File 321806

Re: 388/392 West Street North, City of Orillia
Site Access - Response to City Comments

Figure 1: Opposing Left Turn Movements

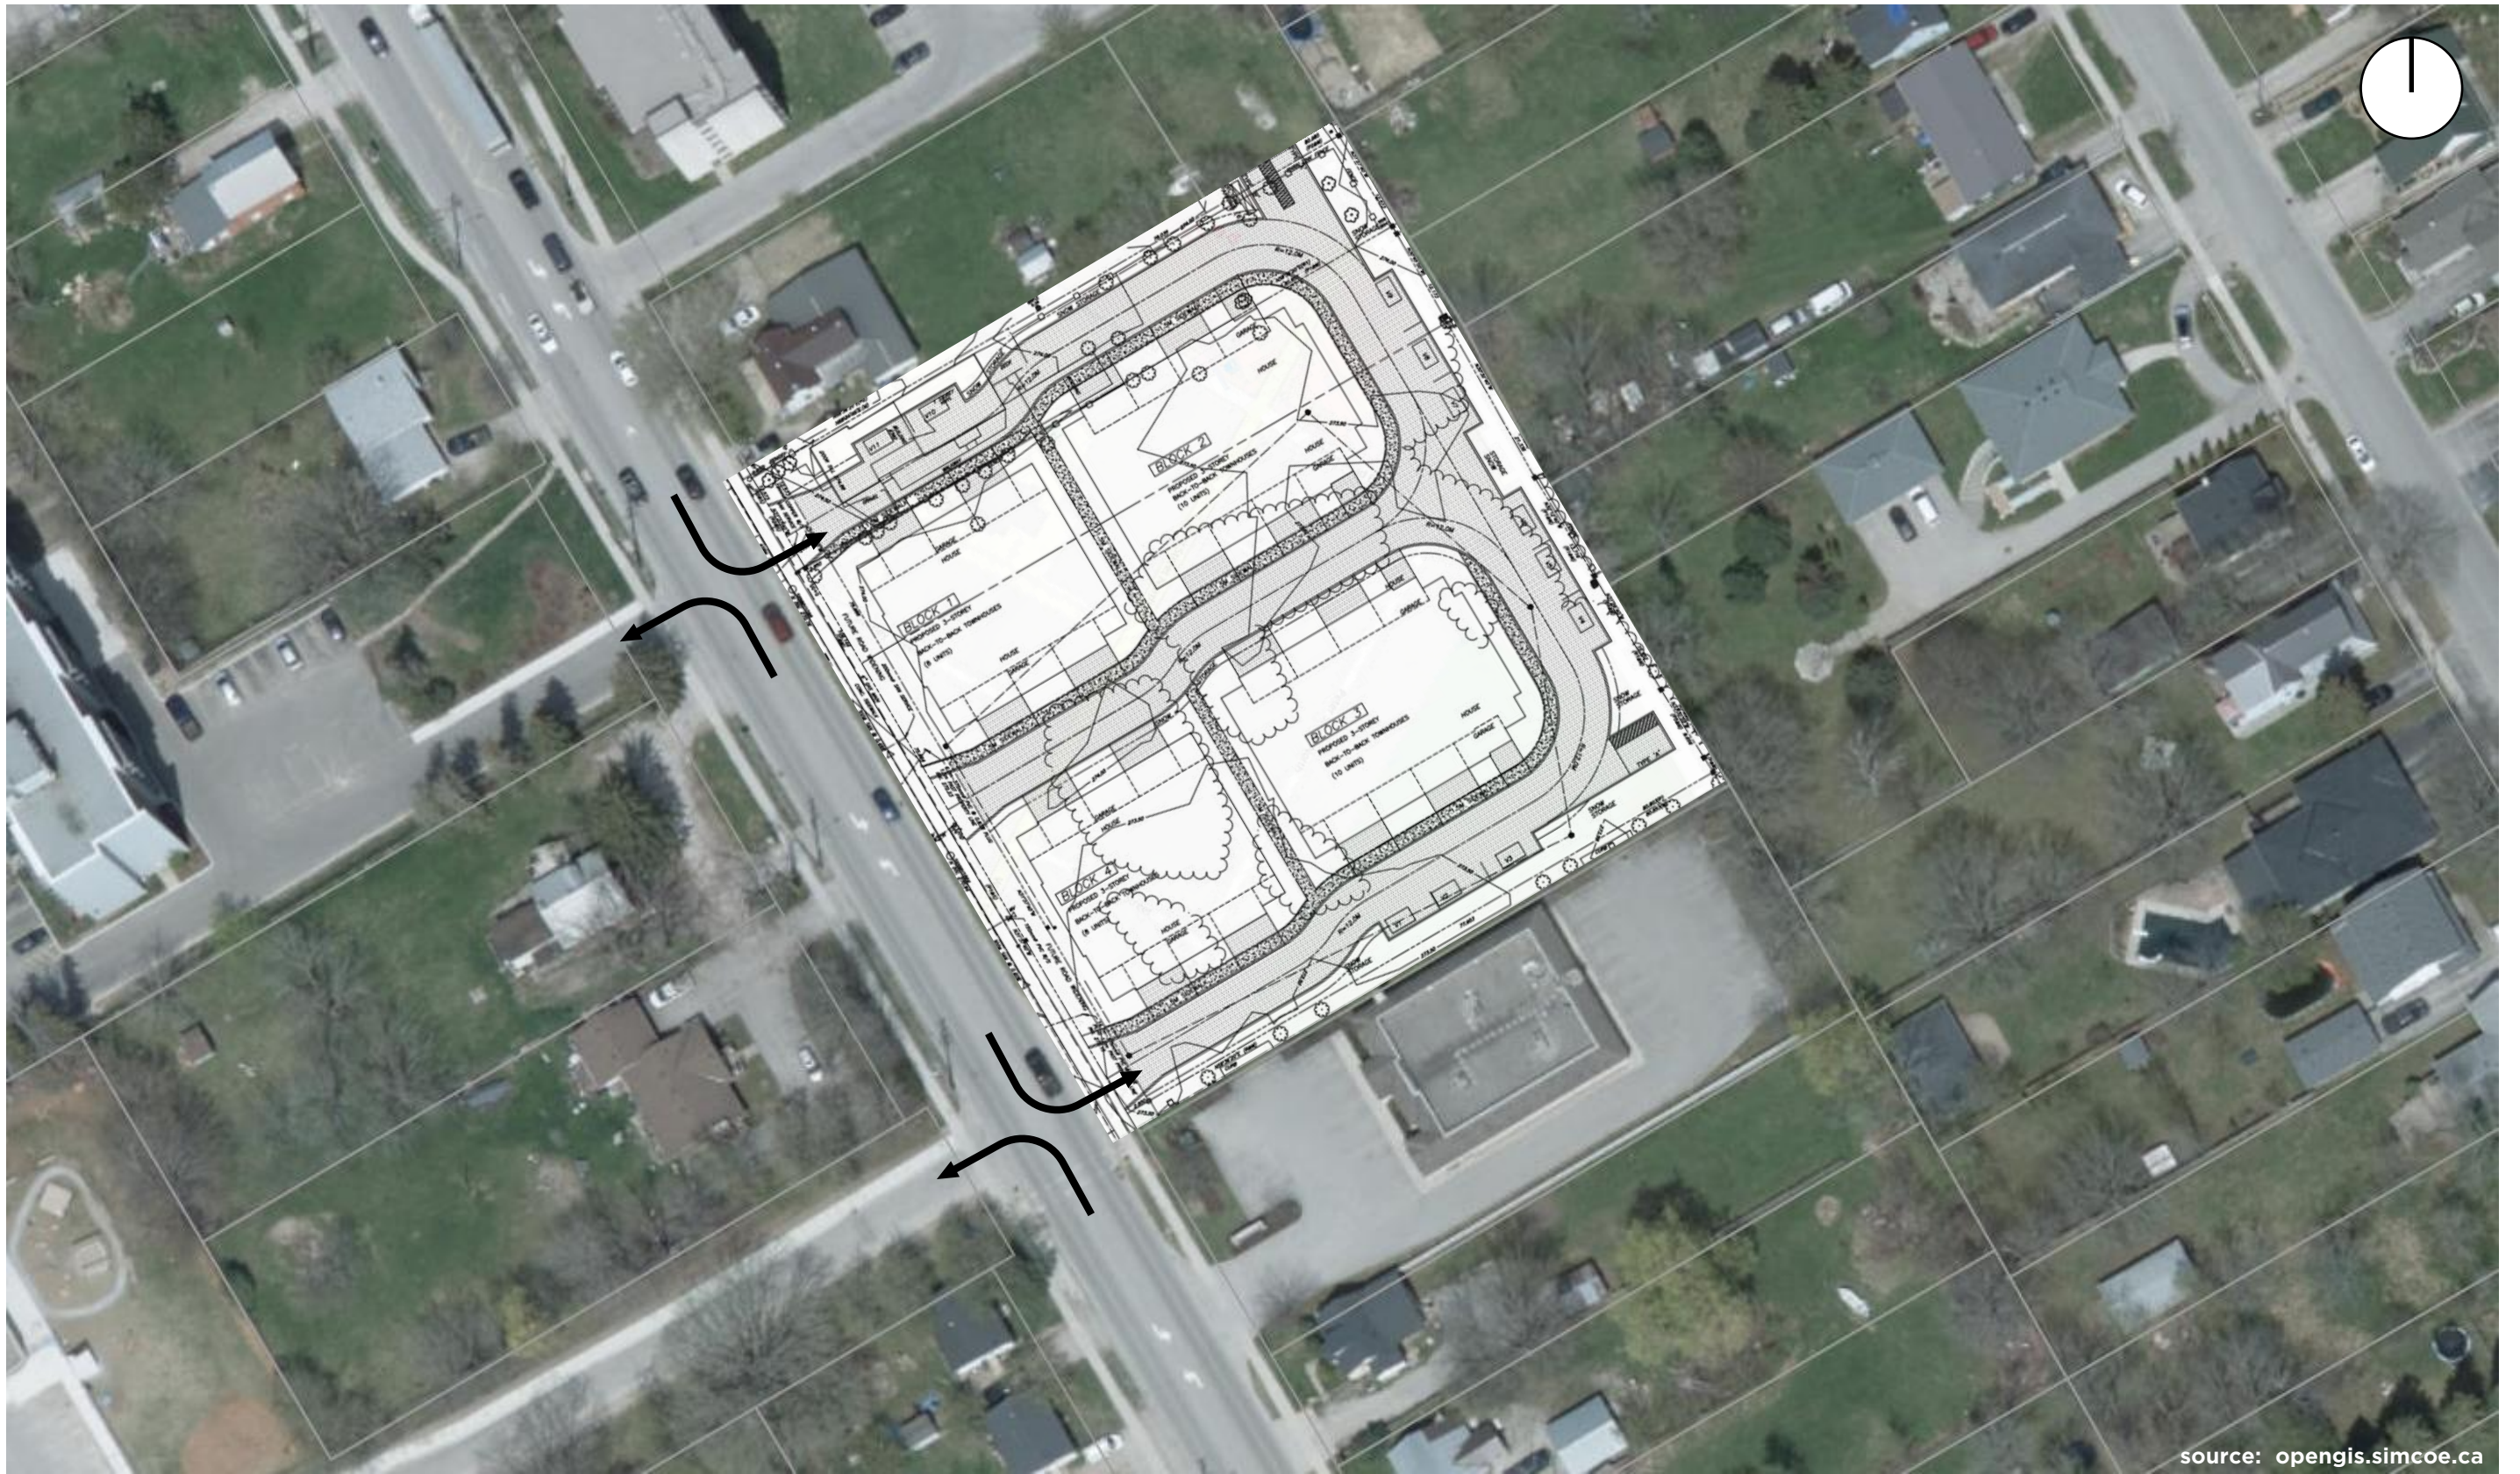
The City has requested justification for the provision of 3 access points on West Street North in context of the intent and function of an arterial road, as described in the *Official Plan*. The relevant sections of the *Official Plan*, as identified by City staff, are as follows:

With respect to spacing considerations for access points on the opposite side of the road, TAC guidelines do not identify a minimum separation; however, the guidelines do note that moderate to high volume access points should be located so as to avoid inbound overlapping left turn movements. For low volume driveways, TAC states that access separation does not impact traffic operations and thus is not a necessary design consideration. As such, the review of opposing driveways has been limited to the location of the proposed north access in relation to the existing access to 401 West Street North (Westview Place Apartments), and the location of the proposed south access in relation to the existing entrance only access to Orchard Park Public School. As per TAC guidelines, the location of the subject driveways in relation to the opposing residential driveways (i.e. low volume driveways) is inconsequential.

The north access will be located approximately 1.5 metre north of the access to 401 West Street North (measured centre of access to centre of access) whereas the south access will be located approximately 0.5 metres north of the Orchard Park Public School access. In context of inbound left turn movements, the proposed offset at each access is such that prevents overlapping (as illustrated in Figure 1).
